Appl. No. 10/731,496
Amdt. dated August 22, 2006
Reply to Office action of May 23, 2006

AMENDMENT TO THE DRAWINGS

Fig. 2

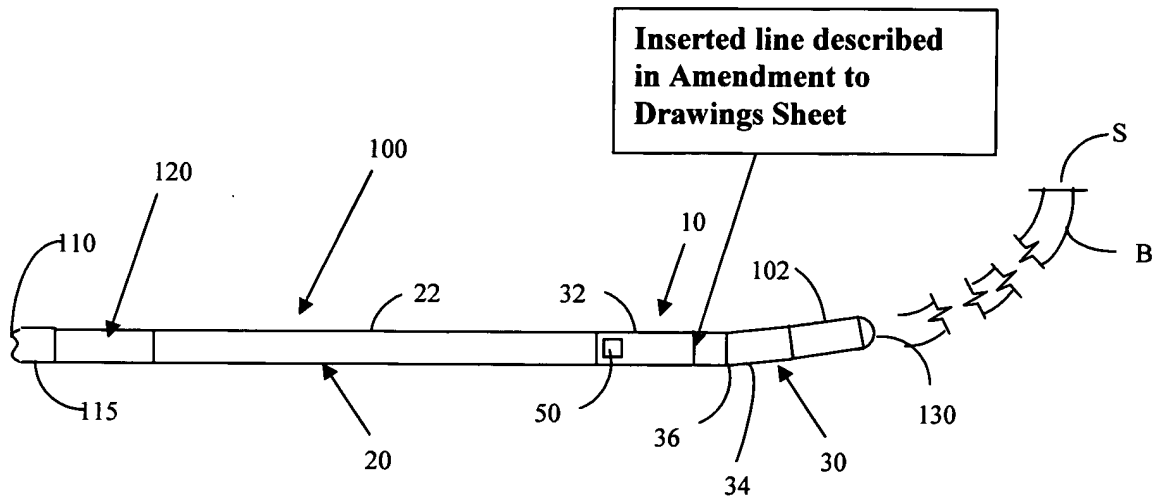
- Fig 2
 - Line was missing in drawing adjacent to Item 36. Line has been inserted so as to
 - clearly identify the division between Items 32 and 34
- Fig 3.
 - Line as missing in drawing adjacent to Item 36. Line has been inserted so as to
 - clearly identify the division between Items 32 and 34
- Fig 4.
 - Numerical call out for Item 24 was moved to provide clarity
 - Item 32 was identifying the wrong item and has been corrected to illustrate the appropriate component
